REVISION TRANSMITTAL

EQUIPMENT/FURNISHINGS - FORWARD DIVIDER DOOR/GARMIN INTERFACE

700 (Citation Longitude)

SB700-25-02
Page 1 of 6

Figure 1. Divider Door/Garmin Interface Wiring Modification (Sheet 1)

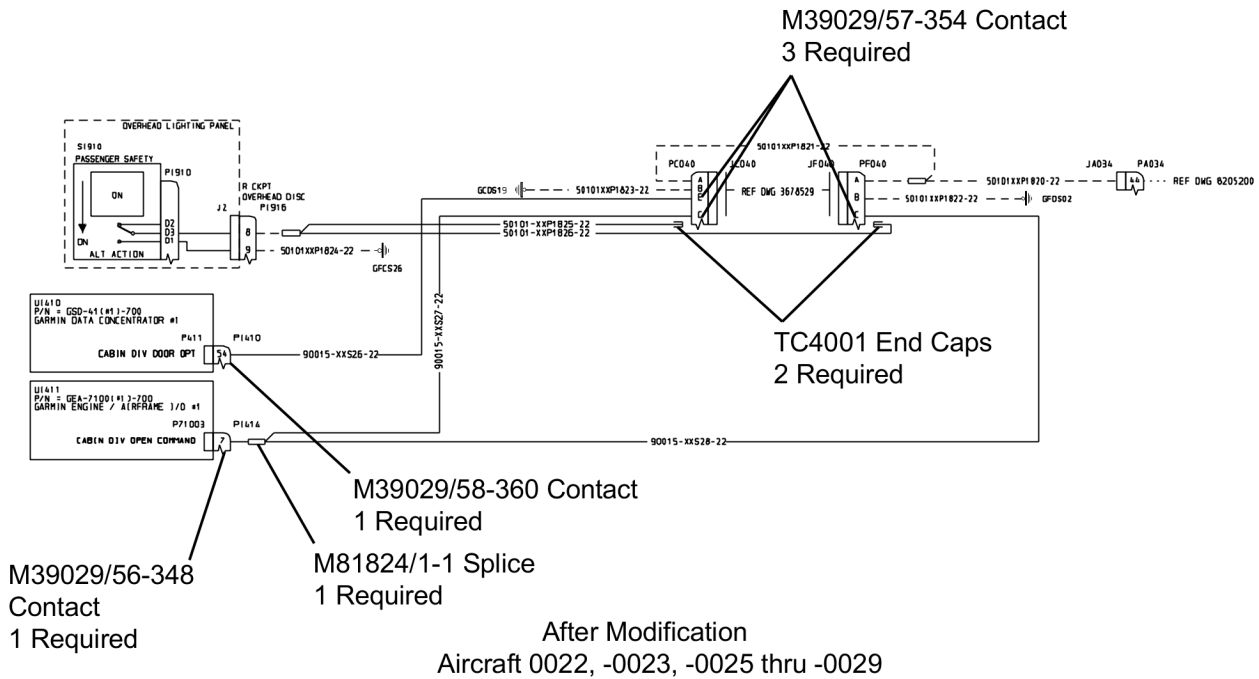
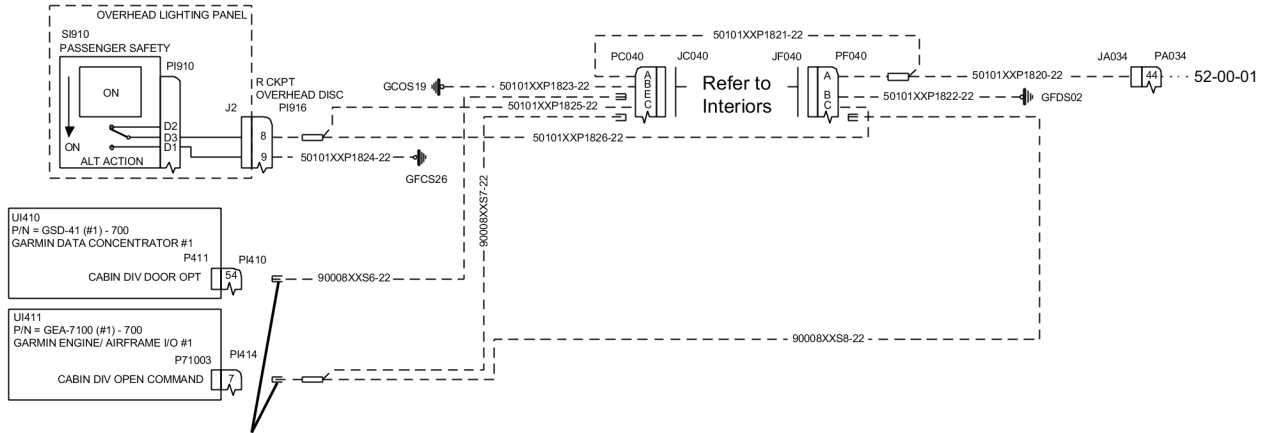
2. (Refer to Figure 1, Sheet 1.) Aircraft -0022, 0023 thru -0029, do the wiring modification per wire diagram.
 - A. After wiring modification is complete, Using an indelible marker, identify circuit breaker HZ233 located on the right DC power junction box circuit breaker placard as 'FWD DIVIDER'.

Before Modification
Aircraft -0022, -0023, -0025 thru -0029

After Modification
Aircraft 0022, -0023, -0025 thru -0029

Figure 1. Divider Door/Garmin Interface Wiring Modification (Sheet 2)

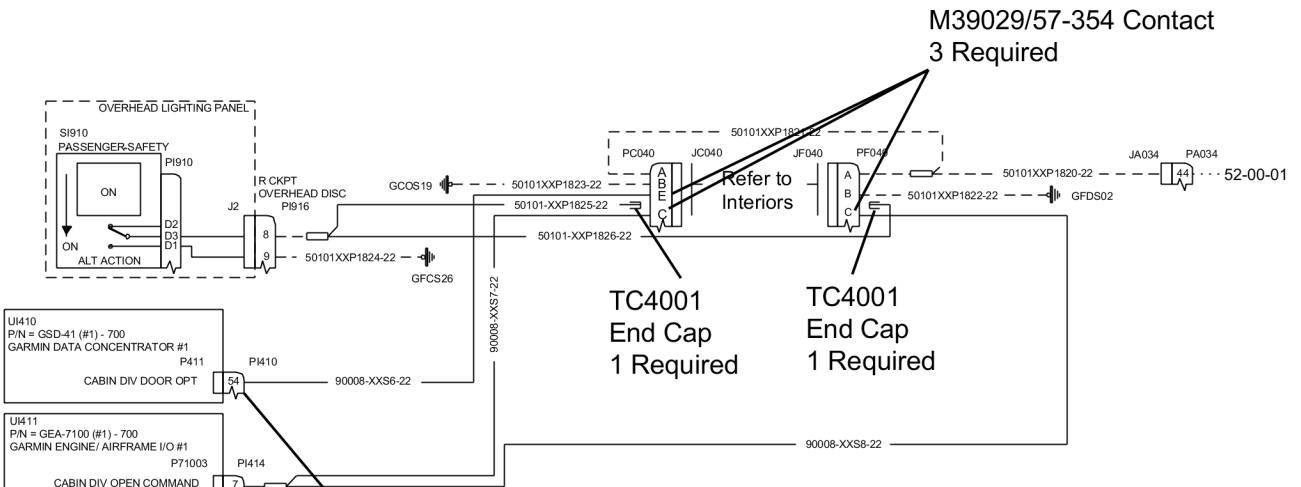
- A. Changed Contact part number from 'M39029/48-348' to 'M39029/56-348' in kit SB700-25-02-0 and SB700-25-02-01.
- B. Updated illustrations to reflect correct Contact part number M39029/56-348.

3. (Refer to Figure 1, Sheet 2.) Aircraft -0032 do the wiring modification per wiring diagram.
 - A. After wiring modification is complete, Using an indelible marker, identify circuit breaker HZ233 located on the right DC power junction box circuit breaker placard as 'FWD DIVIDER'.

Before Modification
 Aircraft -0032

After Modification
 Aircraft -0032

M39029/56-348
 Contact
 1 Required
